311 S Martin Luther King Jr Drive | Temple, Texas

Design Recommendations were requested by property owner Stephanie A. Harris and Main Street Manager Dan Kelleher with assistance from Kelly Atkinson, Sr. Planner and Historic Preservation Officer. The owner is keen to preserve the character of the

DESIGN RECOMMENDATIONS

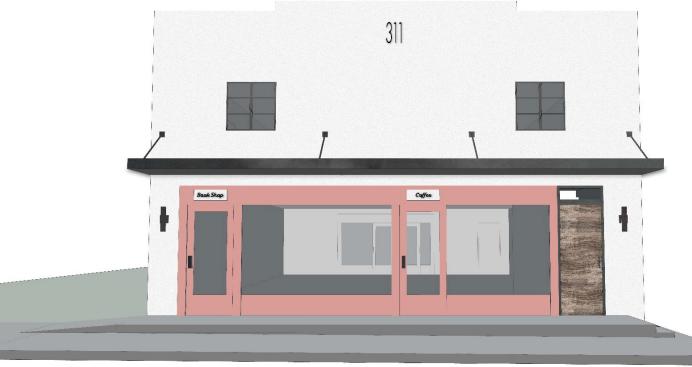
- 2nd floor steel windows on Front Façade are restored and kept as seen in the 1986 photo.
- On the 1st floor a wooden door in steel frame is added giving access to the residential units. Fixed panels are kept on each side of the façade to resemble the doors seen on the same 1986 photo and balance the composition. The space in between has a new contemporary configuration that allows for a large window display area and for natural light in the retail spaces. The colored frame protrudes slightly from the wall aiding the transition of the different materials.

- A tie rod canopy is reintroduced but extended across the whole front façade to protect customers and residents from the weather and for overall aesthetics. Recessed light fixtures are located in the canopy.

- A 2-3 color scheme is recommended for the façade.
- Blade signs are hanging from the canopy to indicate the business on each retail unit.
- The Canopy ledge and tie rods, the transom and wooden door frames, the door fixtures, and the building number are all the same metal finish material as the second-floor window frames.

- Two more color schemes are presented as options.
- These two alternatives present the Store Signs on a designated area above the door that sticks out from the colored frame.
- Ramps/Sloping Sidewalks should meet accessibility requirements for TAS and ADA. For the peach color alternative ramp must start at a distance that meets the requirements for proper access to the retail unit ad provide a level transition to access door.
- This option also presents outdoor light fixtures located at each side of the building.

1st FLOOR PLAN DIAGRAM

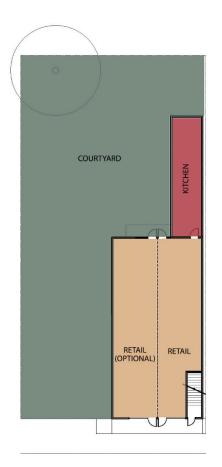
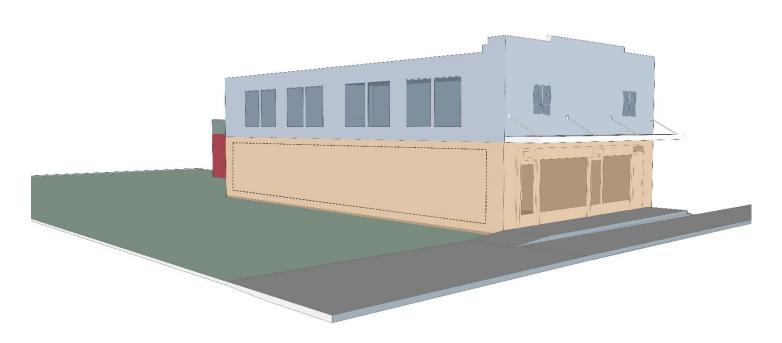
- Retail Units occupy the First Floor.
- Residential Studios are located on the Second Floor.
- A service area is located as a new addition on the back connected to the main building.
- The rooftop of the new addition serves as a terrace for the residential units and as a second means of egress.
- Courtyard area provides space for business to expand, outdoor sitting and other activities can happen here.
- Designated Area for Public Art.
